MAEDA et al.

Serial No. 10/714,935

Amendment Accompanying Request for Continued Examination

FIG. 17 Conventional Art

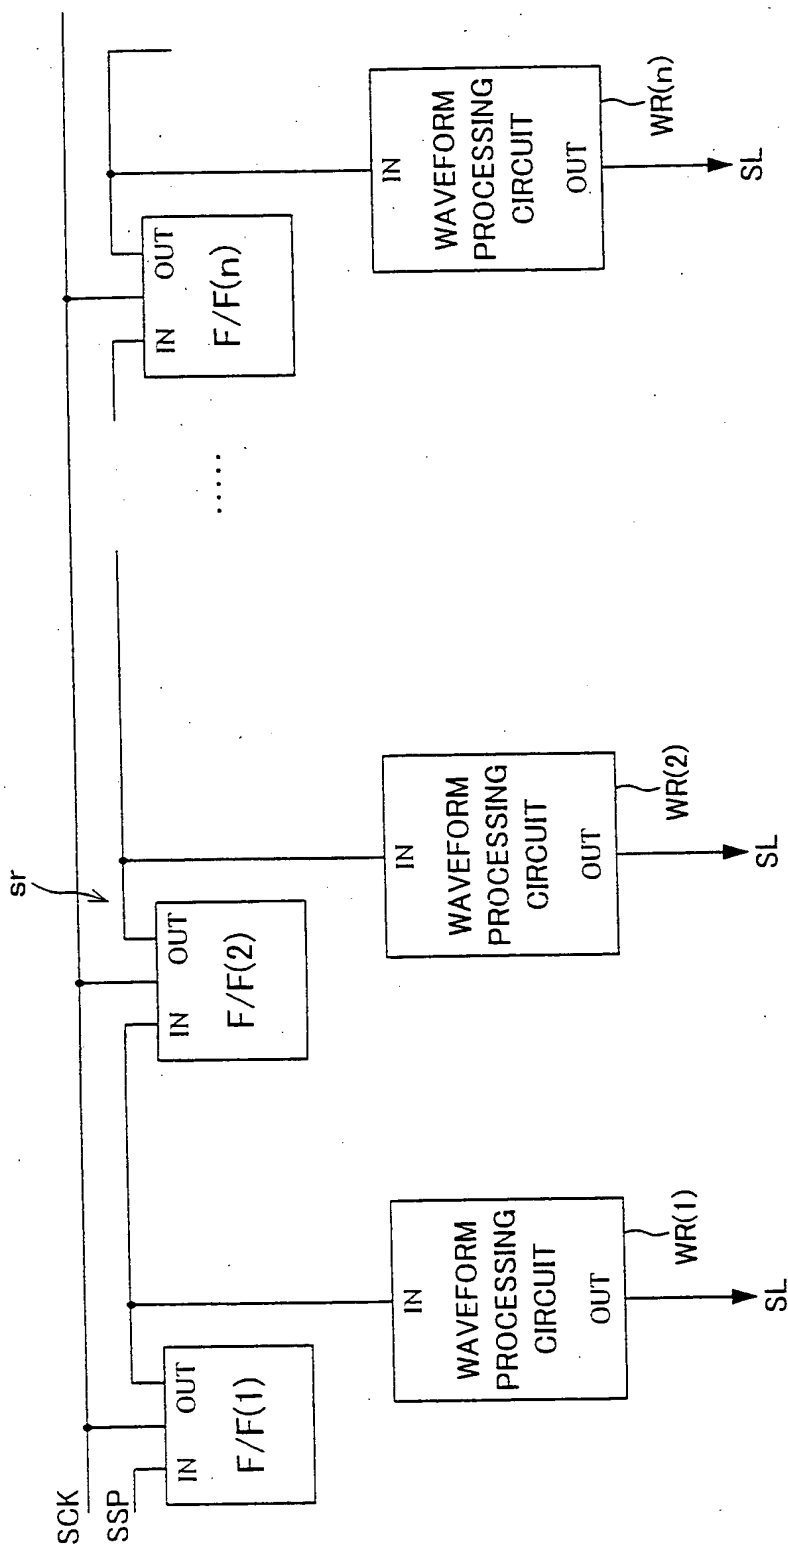
Figures 17-20 have been designated with the legend "Conventional Art". This legend is consistent with the description at, for example, page 19, line 18 et seq. No new matter has been added and the Examiner is invited to independently confirm that this is the case.

As required in the office action, Figures 17-20 have been designated with the legend "Conventional Art" based on the description at pages 19-20 of the specification, for example. Annotated Drawing Sheets Showing Changes and Replacement Drawing Sheets are included in the Appendix.
